INTERNATIONAL
URANIUM (USA)
CORPORATION

March 11, 2002

Re: U.S. Nuclear Regulatory Commission letter of January 14, 2002
White Mesa Uranium Mill
Source Material License No. SUA-1358
Docket No. 40-8681

Comparison of White Mesa Mill Ore Storage Radon Progeny Values (89-90, 00-01)
Graph I

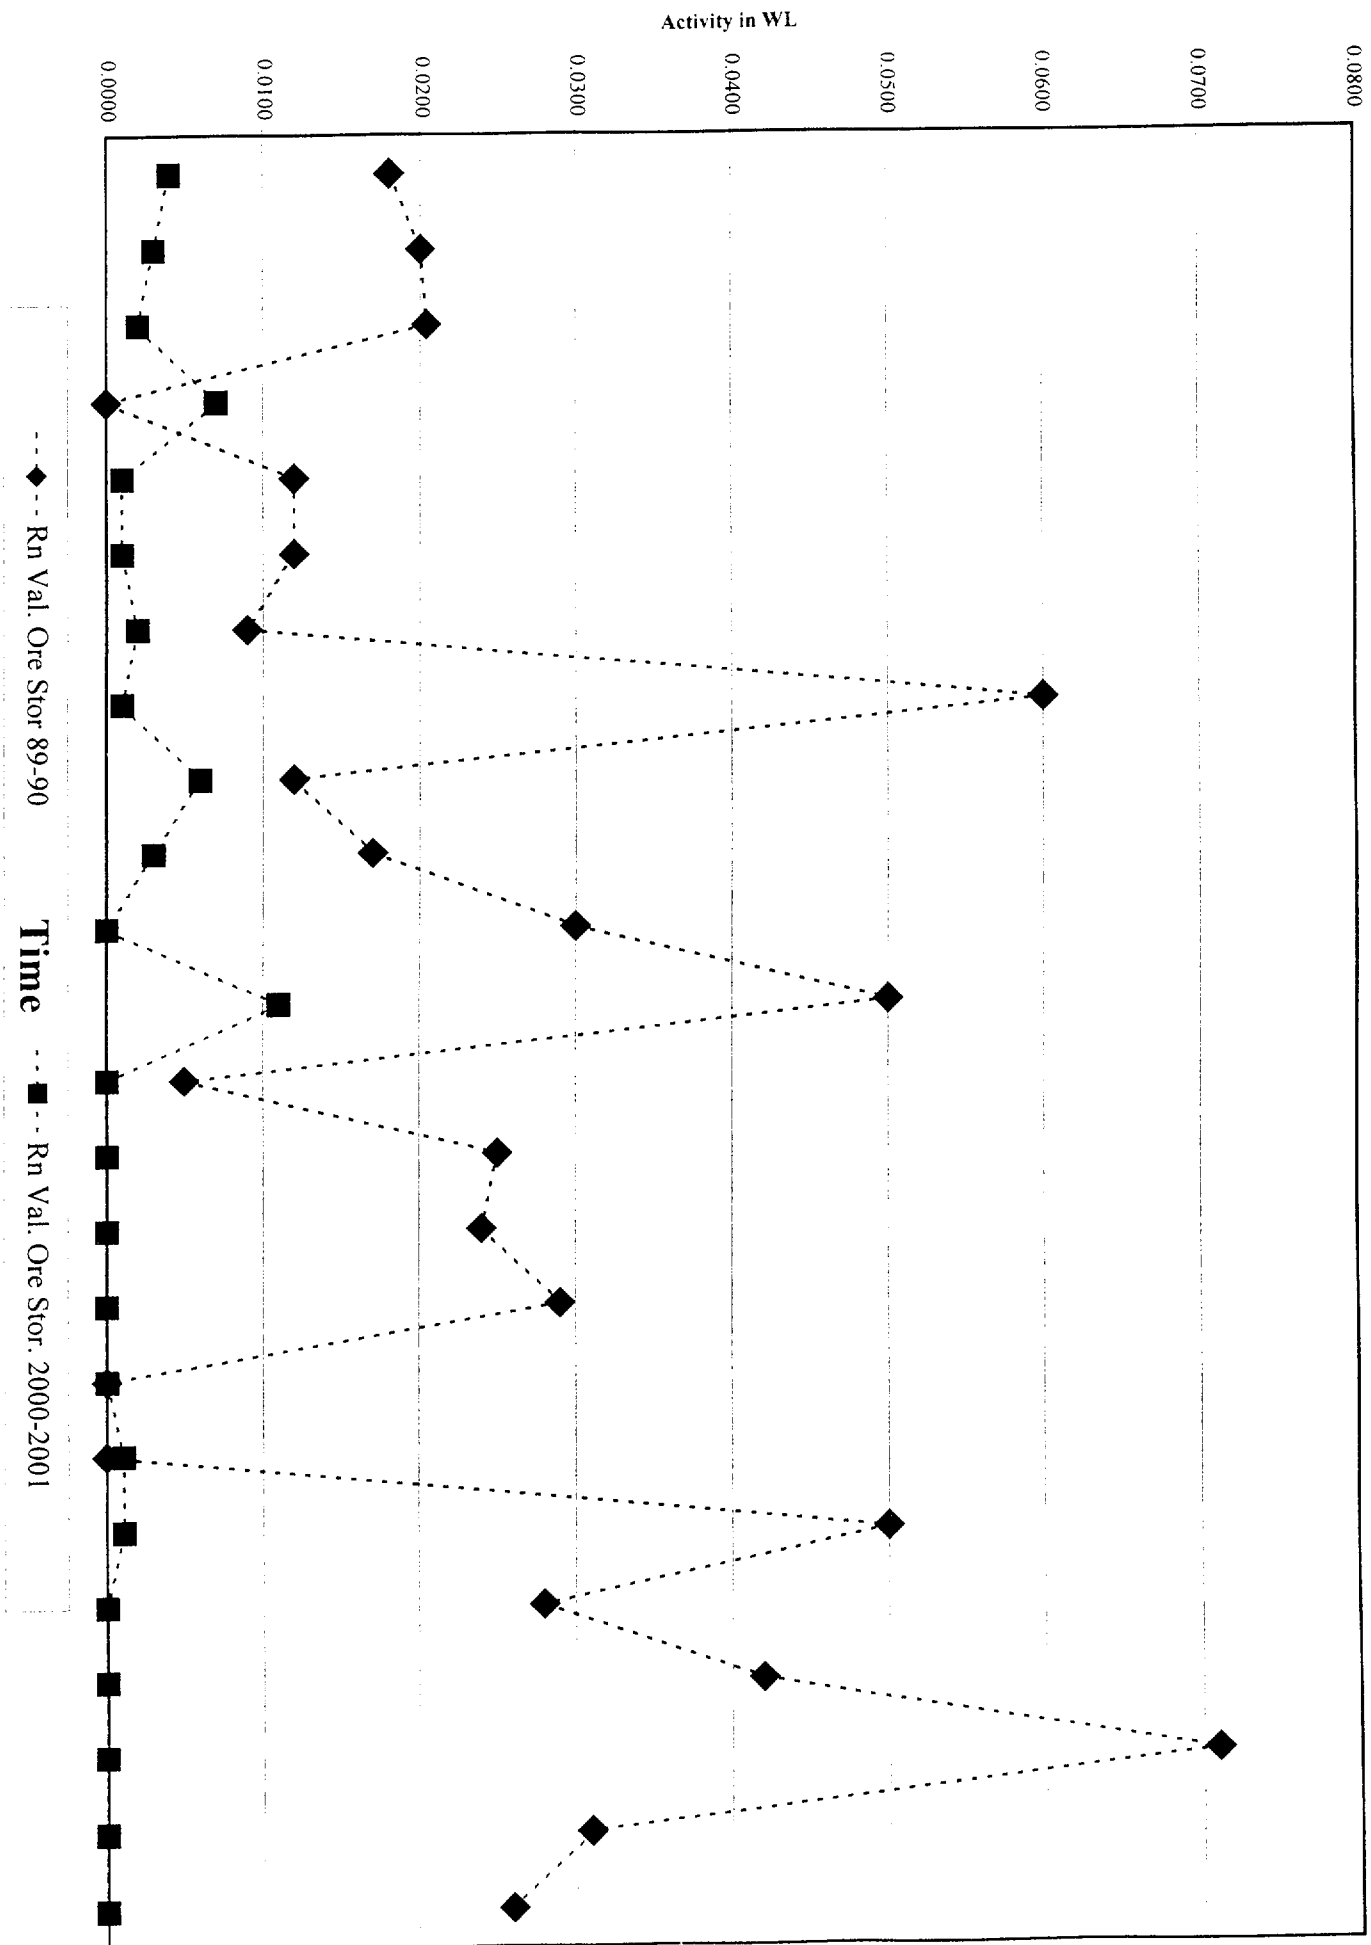
Radon Daughter Working Levels (WL) (note that radon daughters include thoron) were measured each month throughout the ore stockpiles, at various locations for the periods of 1989 – 1991 and 2000 – 2002. These results are illustrated in Graph I (attached). It is interesting to note that over the period of 2000 – 2002, when alternate feed ores are being managed in stockpiles, there have been very few measured radon daughter concentrations above the minimum detectable activity (MDA) of 0.011 WL. Conversely, when mined ore was stockpiled, over the period of 1989 – 1991, the measured radon daughter levels were all above the MDA.

As noted above, the tonnage of mined ore stockpiled in the time period 1989 – 1991 was approximately four times the amount of alternate feed ore stockpiled during 2000 – 2002. Although during the 1989 – 1991 time period, the radon daughter concentrations were measurable above the MDA, the maximum concentration measured was still low. At 0.07 WL, the maximum concentration of radon daughters measured during storage of the mined ore was less than 22% of the allowable radon concentration contained in 10 CFR Part 20, Appendix B for occupational exposure. The average radon concentration over this period was more than an order of magnitude lower, at 0.027 WL. This level of radon emission, measured at a point in the center of the Mill yard, is only 8.0% of the concentration allowed for worker exposure. In addition, radon is measured on a weekly basis at the nearest residence, with the result typically being nondetectable.

White Mesa Mill U-nat Airborne Particulate Values of 1989-90 Compared to Values for 2000-01at BHV-1, BHV-3 (bkgd.), and BHV-5

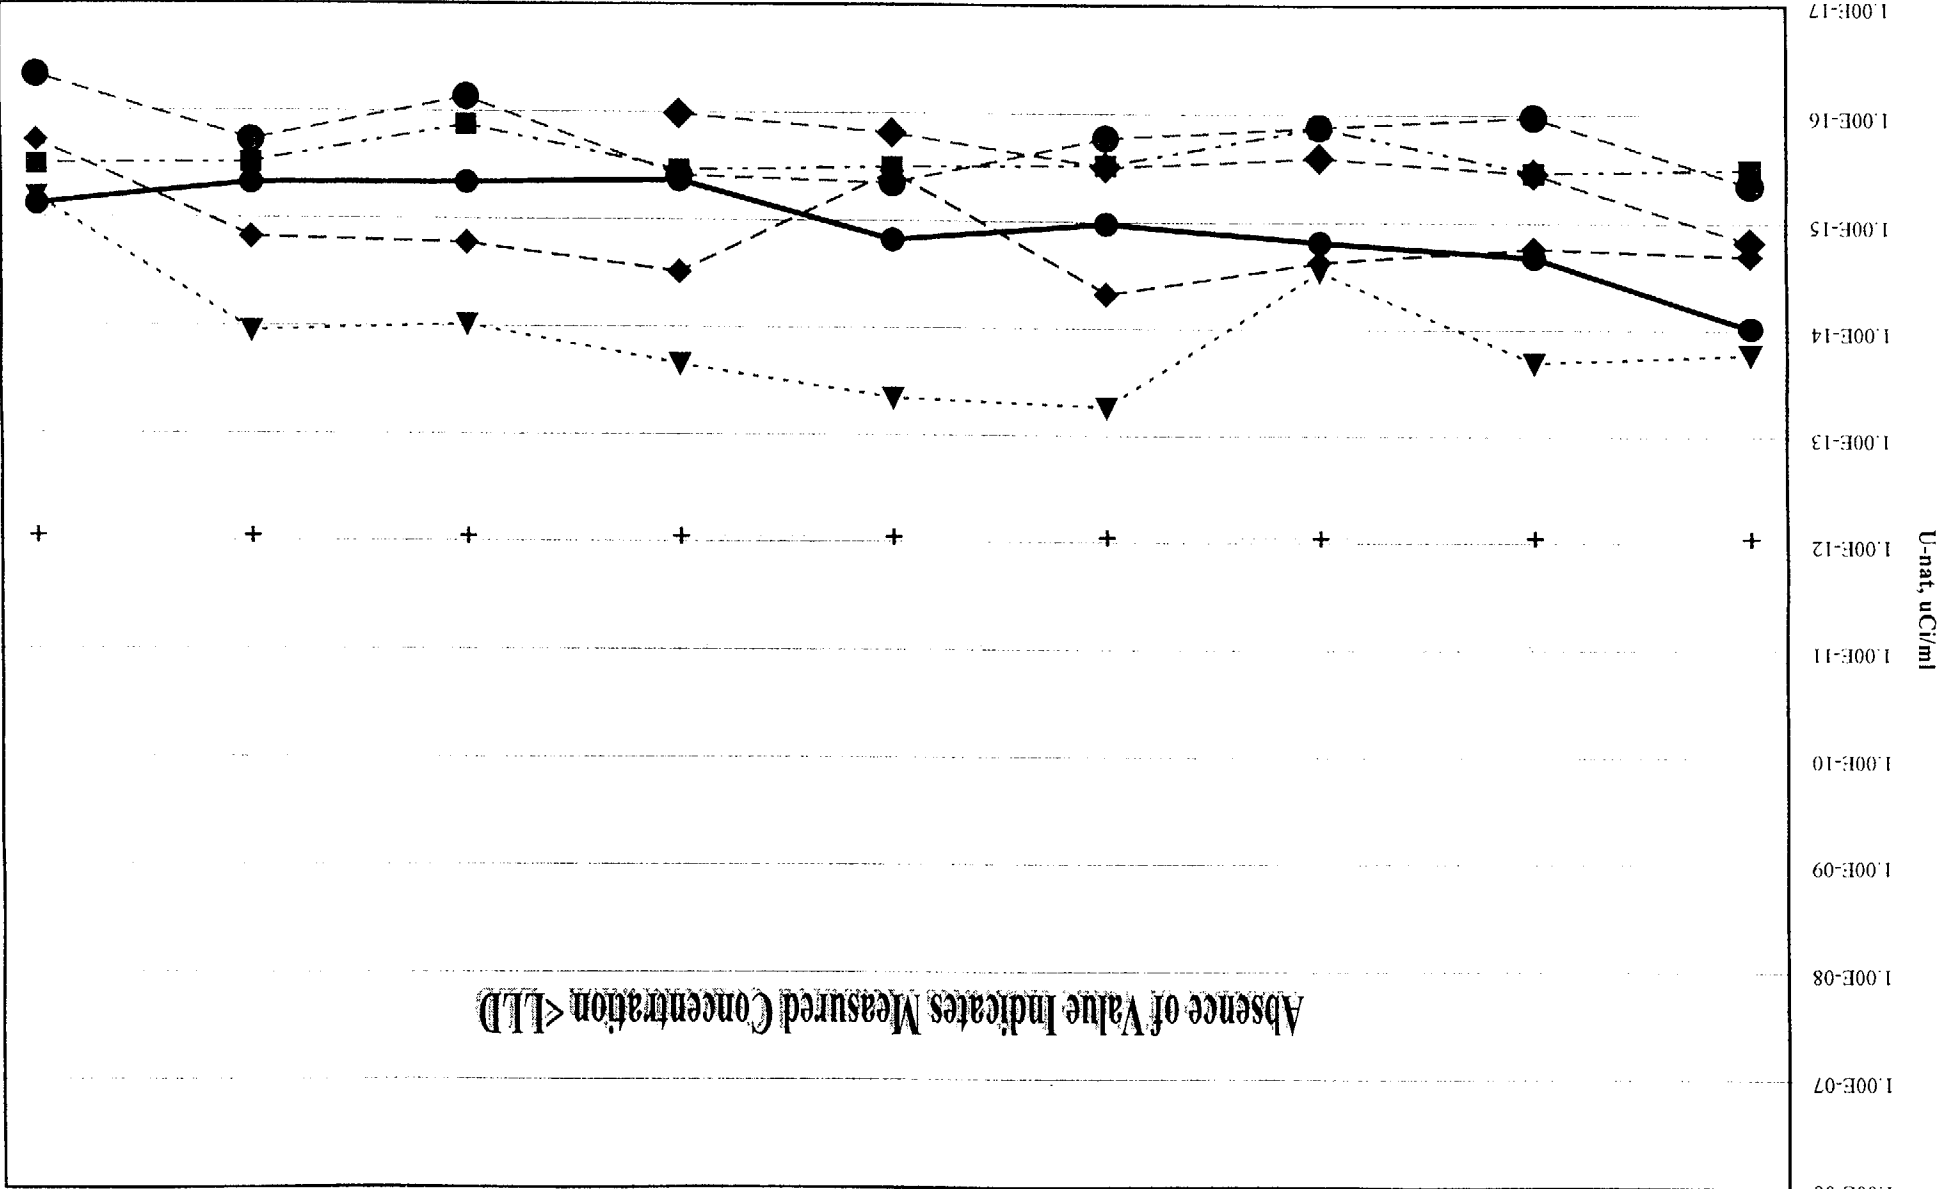
Continuous uranium airborne particulate samples also have been taken at five boundary environmental monitoring stations (see attached Figure). The results of two environmental monitoring stations BHV-1 and BHV-5 are compared to the environmental background monitoring station BHV-3, and are also compared against each other for the comparative ore management periods. Environmental monitoring station BHV-5 is located nearest to the center of the ore storage area approximately 400 meters distant from the center of the storage area, in the southeasterly direction. The environmental monitoring station BHV-1 is located at the mill boundary directly north of the center of the storage area, approximately 1.6 miles away. Environmental monitoring station BHV-3 is located approximately 9 miles directly west of the Mill site, and due to its remote location, it is the station from which data have been gathered to represent background radionuclide particulate concentrations in the Mill site area. Samples are collected continuously at each of the current monitoring stations, and the samples are analyzed for the radioisotopes U-Nat, Ra-226, Th-230, and Pb-210.

Graph II (attached) presents the results for U-Nat only, because it is the parent radioisotope of the uranium decay chain and represents the element the Mill recovers. It should be noted that U-Nat particulate concentrations at each location are equal to or less than the background U-Nat particulate concentrations from Station BHV-1, over both periods 1989-1991 and 2000-2002. The maximum value obtained over the comparative periods are 9.0×10^{-14} $\mu\text{Ci/mL}$ at BHV-5 for the period 1989 – 1991 and 1.0×10^{-14} $\mu\text{Ci/mL}$ at BHV-5 for 2000 – 2002. It is noteworthy that these values are 10.0% and 1.0% respectively of the permissible effluent limits found in 10 CFR Part 20 Appendix B.
